**EDISON IMPACT HUB CONSTRUCTION
DESIGN-BID-BUILD**

PROJECT NO. AH20300003

ADDENDUM NO. 3

ISSUE DATE: 10/22/24

1 ELECTRICAL SITE PLAN
SCALE: 1"=20'-0"

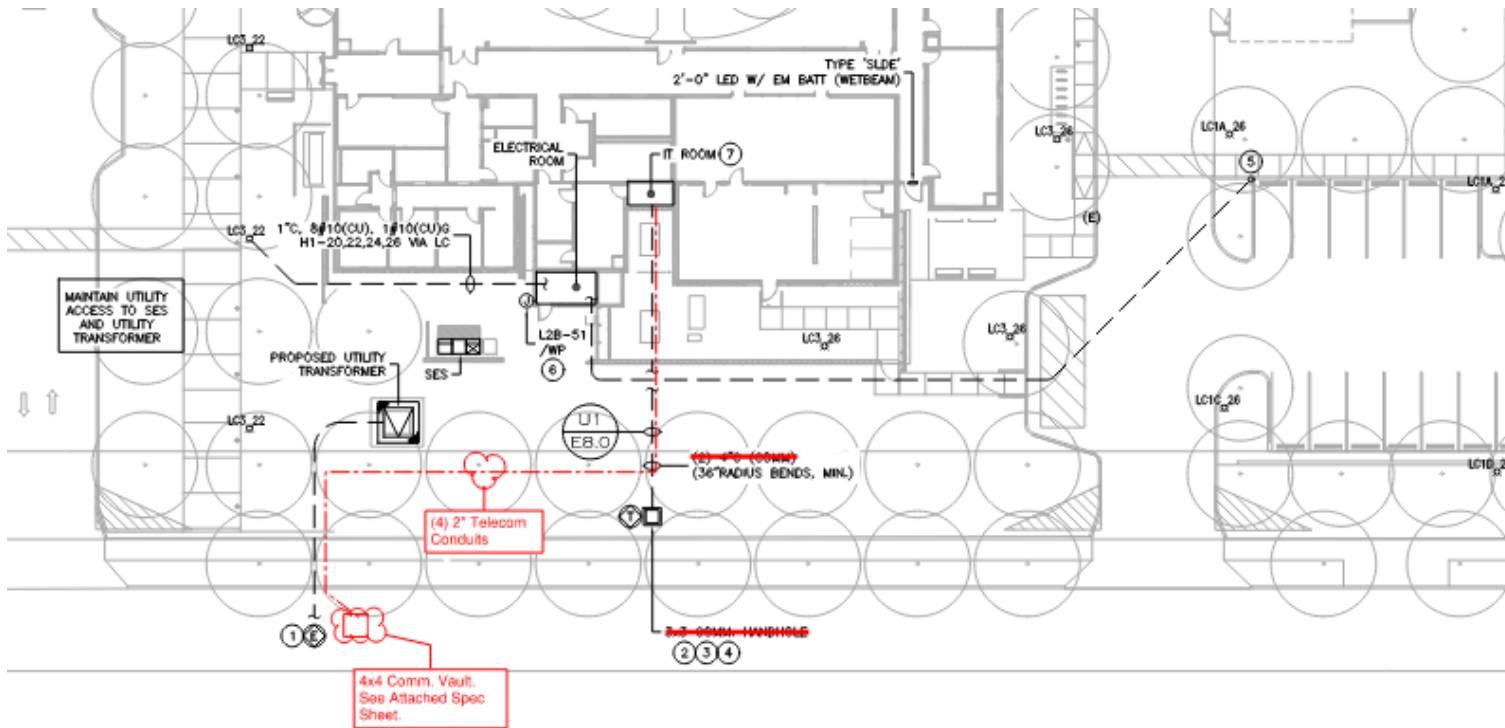
The crossed out section can be disregard Lumen and COX will be responsible for the conduit pathway from our 4x4 vault at the property line to their pole or pedestal that their service will be coming from.

Change to #7 Low Voltage Hand holes. See attached Spec Sheet.
